BCA Assessment Report

Dee Why RSL Club Extension
932 Pittwater Road, Dee Why

Revision 3

11 February 2025

Figure 2 – Roof Plan

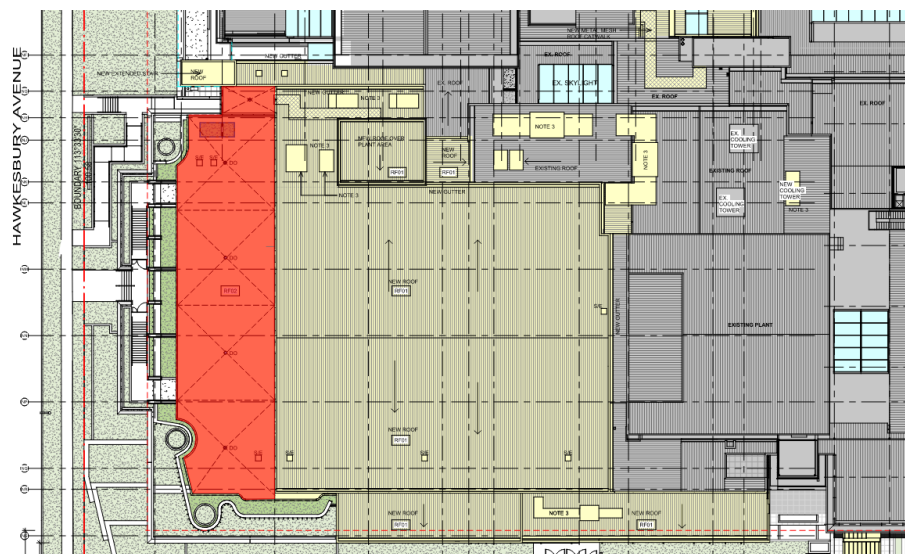
Comment: Any roof areas which are a concrete slab are to be externally waterproofed. Confirmation to be provided of the proposed grades to the falls to floor wastes to be shown in the highlighted areas (red/orange).

Details of compliance with the above are to be prepared by a suitably qualified consultant and submitted with documentation for the CC.
F1D6	<p>Damp-Proofing:</p> <ul style="list-style-type: none"> + This sub-clause requires that moisture from the ground must be prevented from reaching certain parts of buildings as listed. + This sub-clause requires that all damp-proofing materials and termite shields used as damp-proofing must comply with AS/NZS 2904 and AS 3660.1. + This sub-clause lists the buildings and parts of a building that do not need to comply with (a). <p>Comment: Details of compliance with the above are to be submitted with documentation for the CC.</p>
F2D2, F2D3 & F2D4	<p>Wet Area Construction: These clauses set out the construction requirements for wet areas in Class 2-9 Building, in relation to floor and wall materials, surface grading, floor wastes and drainage.</p> <p>Comment: Note - Design Certification required at CC Application stage.</p>
